TCG121SV Series Package Change Notification

Please accept this letter as an official notification of the packaging change of TCG121SV series due to paper gasket reduction. Only TCG121SV series will be affected by this notification.

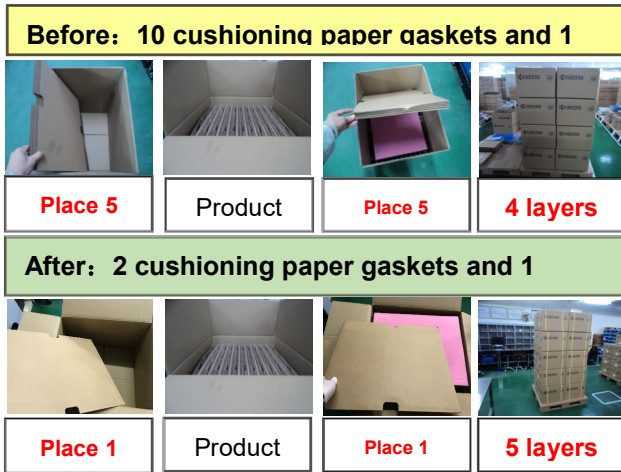
Please refer to detailed packaging change information in next page.

The number of paper gaskets change from 10 pieces to 2 pieces per box.

The height of each box is changed from 331mm to 290mm, other dimensions remain unchanged.

The quantity in each box remains unchanged.
